**PB# 77-7**

**Suburban Builders**

APPLICATION FOR SUBDIVISION APPROVAL  
Town of New Windsor, Orange County, N.Y.

Re: Suburban Builders Subdivision (Cornell Homes)

Area: 5.777 Acres  
Suburban Builders  
Rt 94  
New Windsor, N.Y.

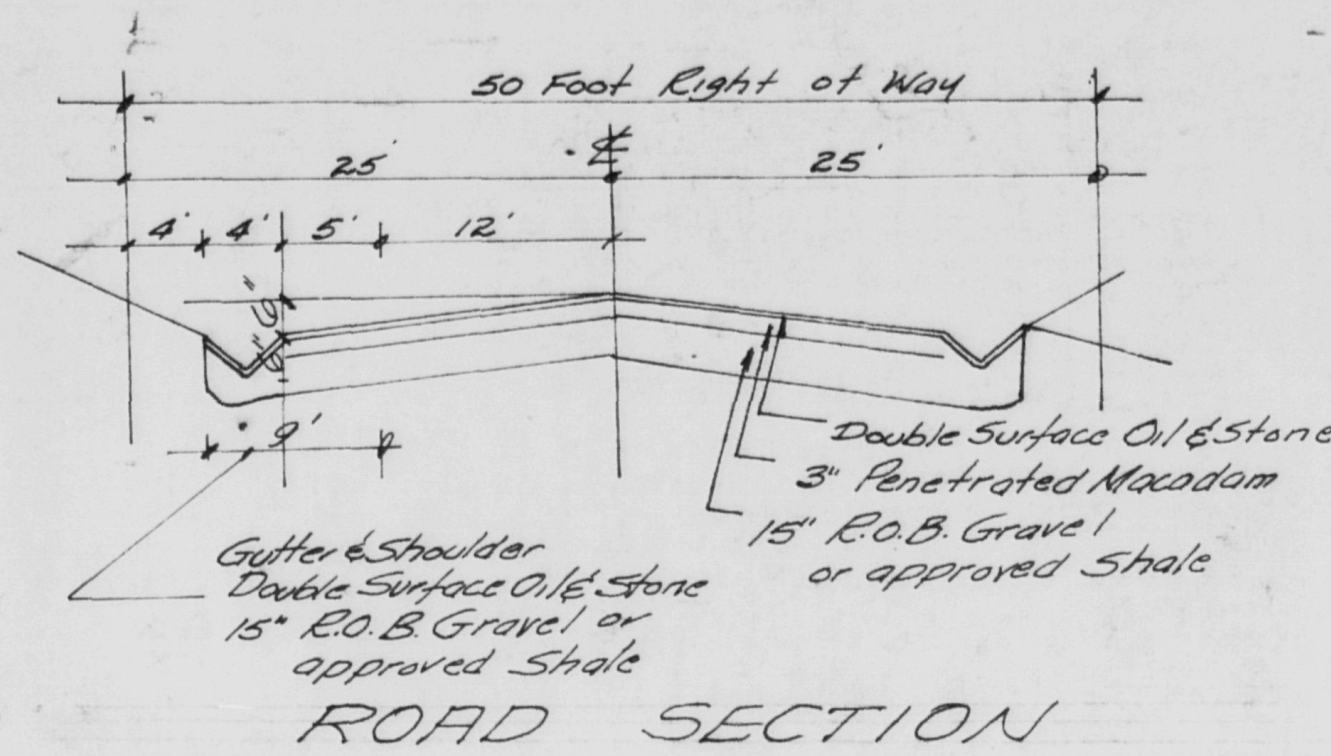
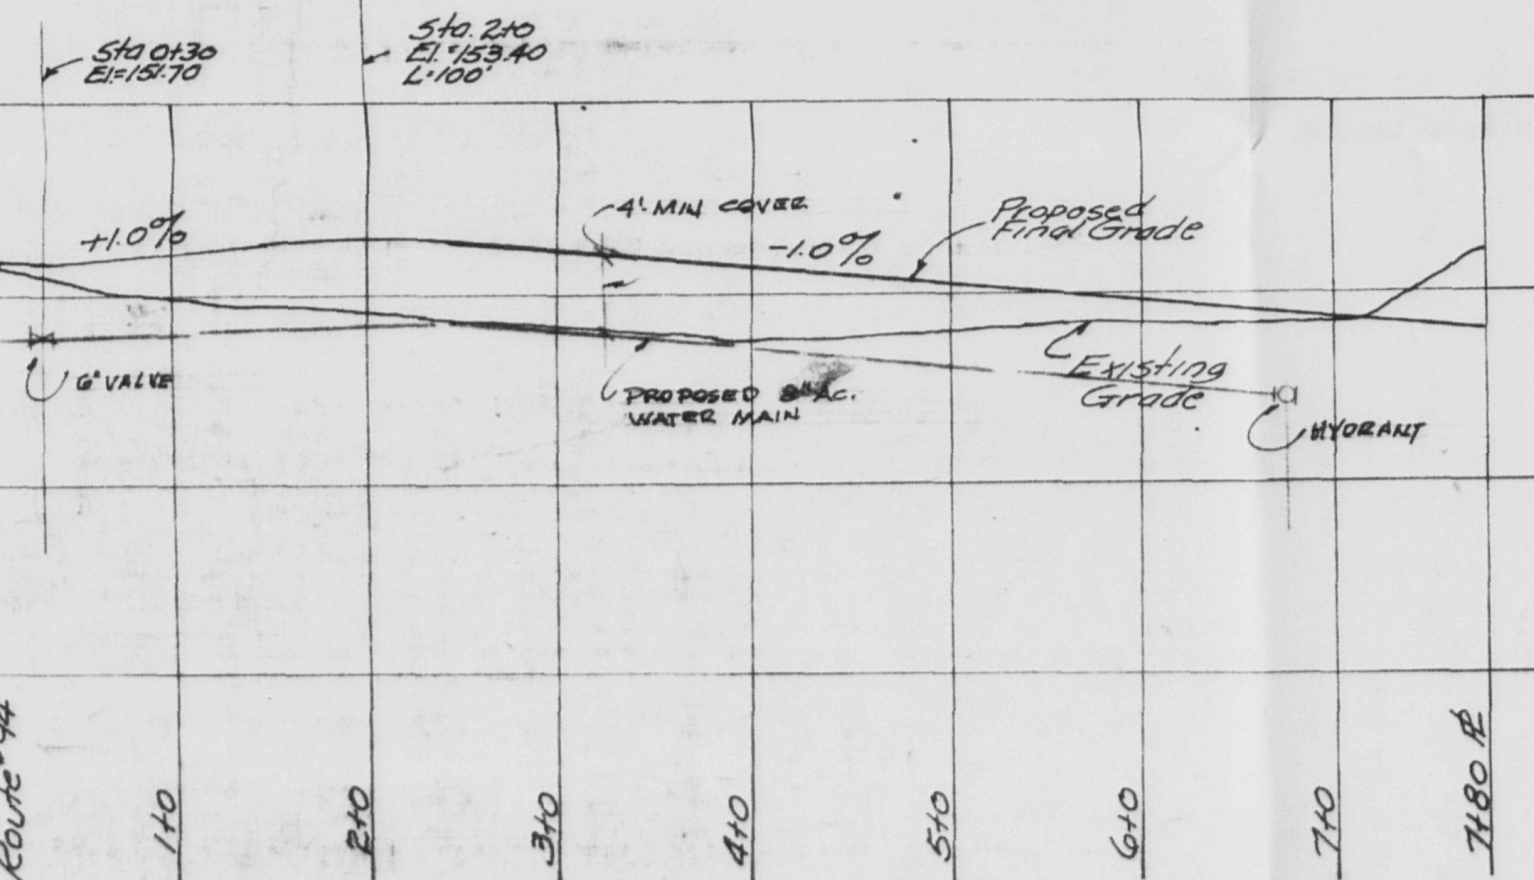
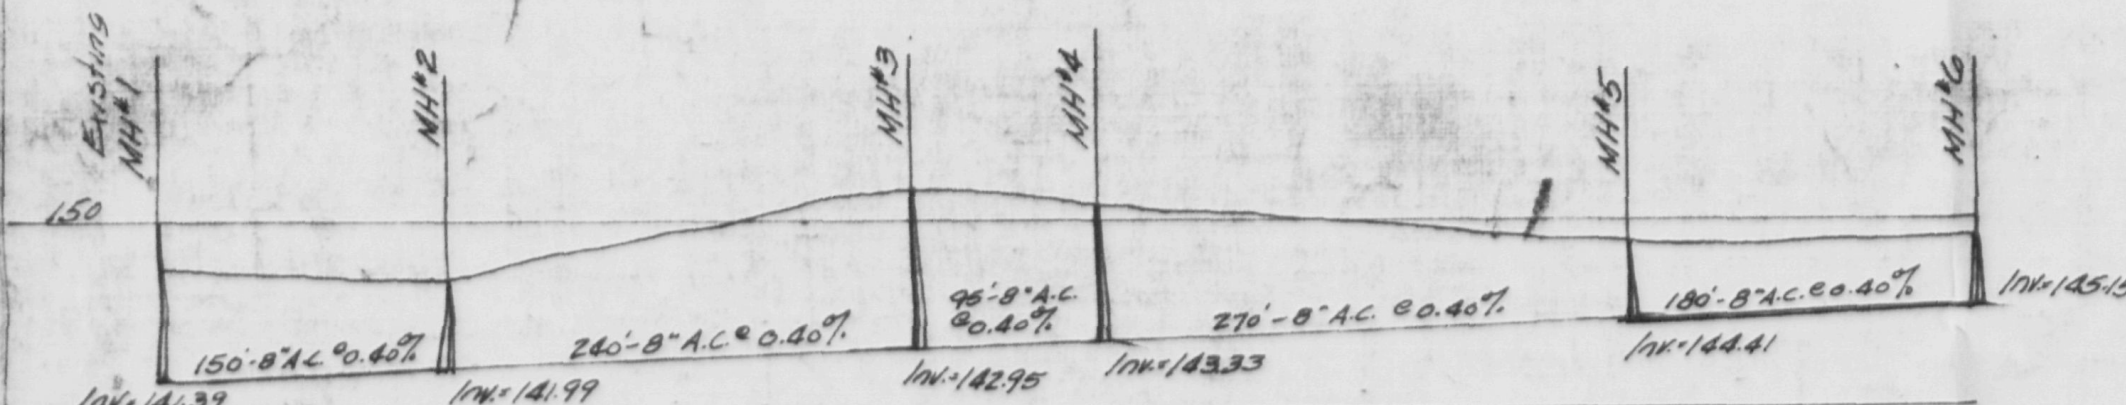
The Plat should have the following additions and changes made prior to preliminary approval.

1. Add the zone district (LB).
2. Road profile minimum grade should be 1% rather than  $\frac{1}{2}\%$ .
3. Minimum lot size required is 12,000 sq. ft. Lots 3, 6, 7, 8, 11 and 13 do not conform to the minimum.
4. Minimum lot width required is 90'. Lots 6, 7, 8, 11 and 12 do not meet the minimum.
5. A side yard of 30' must be maintained between the existing block building on Lot 4 and the property line of Lot 3.
6. Add the road cross-section.
7. Indicate method or location of sewage disposal for Lot 15.
8. Indicate size of existing water main.
9. Show the width of proposed sewer and drainage easements.
10. The almost flat slopes, as indicated by the widely spaced contour lines, may lead to serious site drainage problems. Proposed final lot grades should be indicated if lots are to be filled.

It should be noted that the road section must be changed to conform with the new suburban street specifications, i.e., curbs, 8" run of bank, and 6" pavement.

# WATER MAIN PLAN

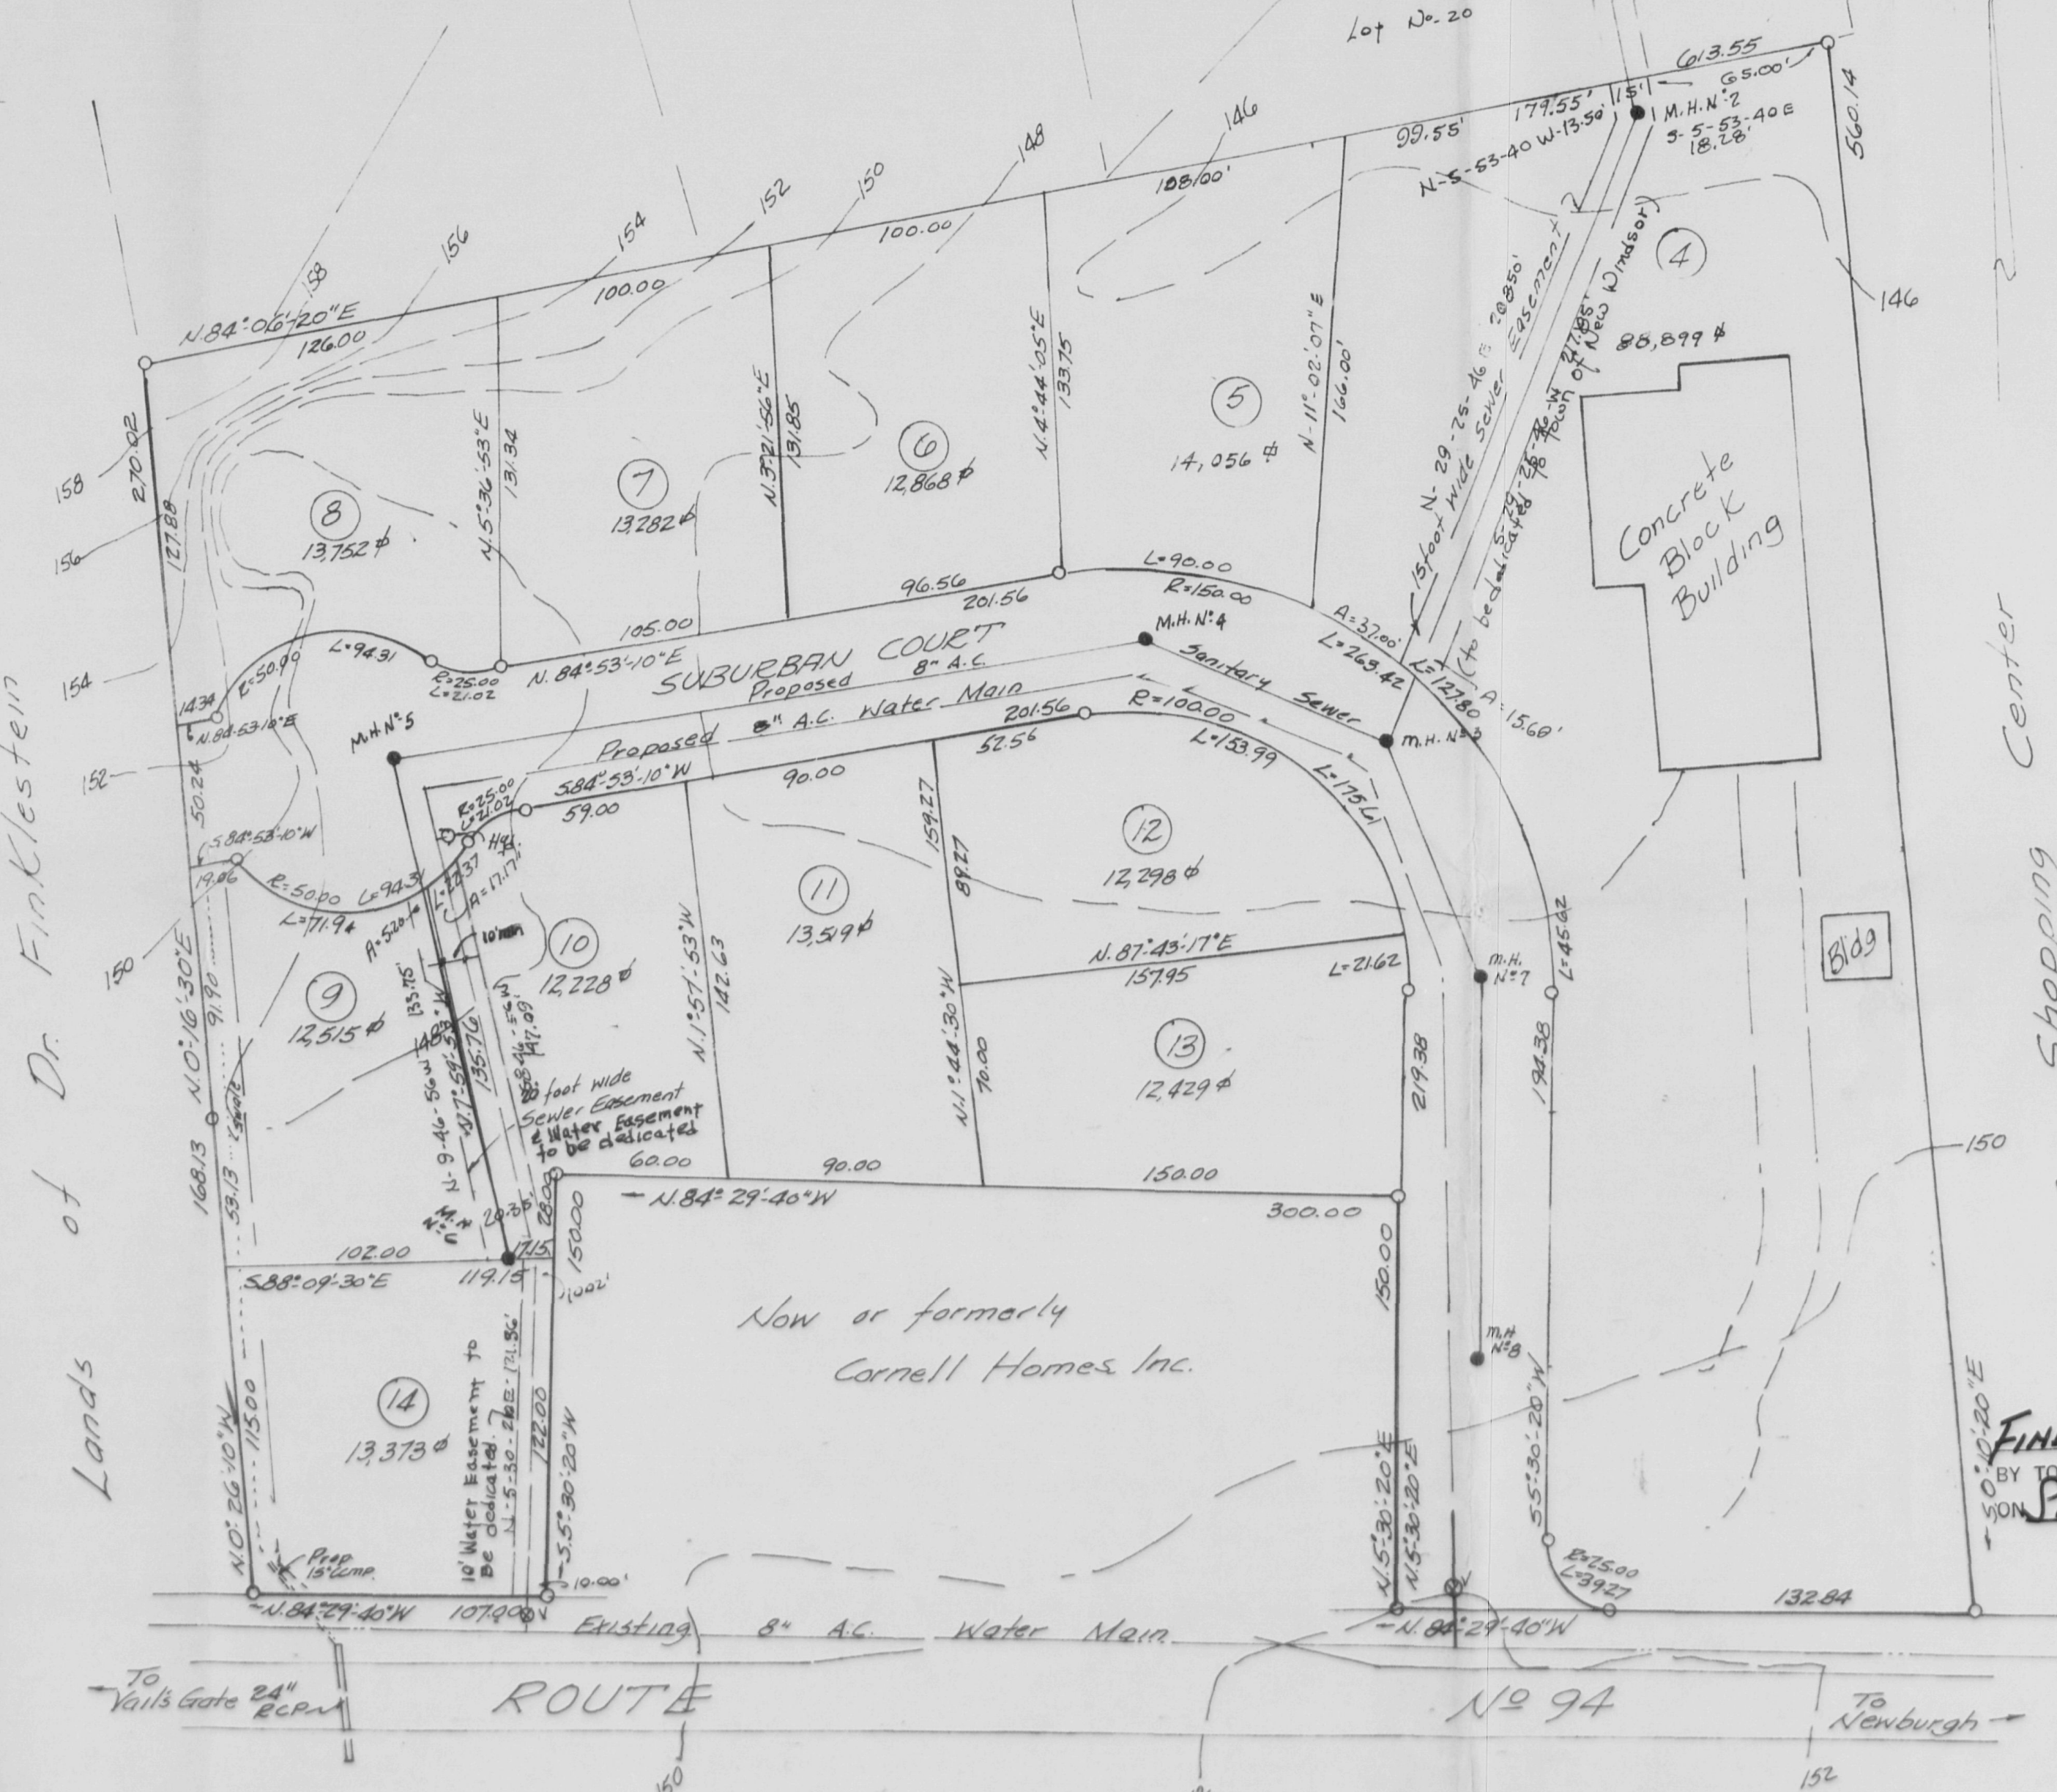
Mr. Dowd: Stated that the water mains should be 8", instead of 6", as shown on the plans.

REVISED 5/10/78 IN ACCORDANCE WITH  
ORANGE COUNTY DEPT. OF HEALTH LETTER - MAY 19, 78.  
5/24/78 to conform to T.S. New Windsor Water  
Standards.
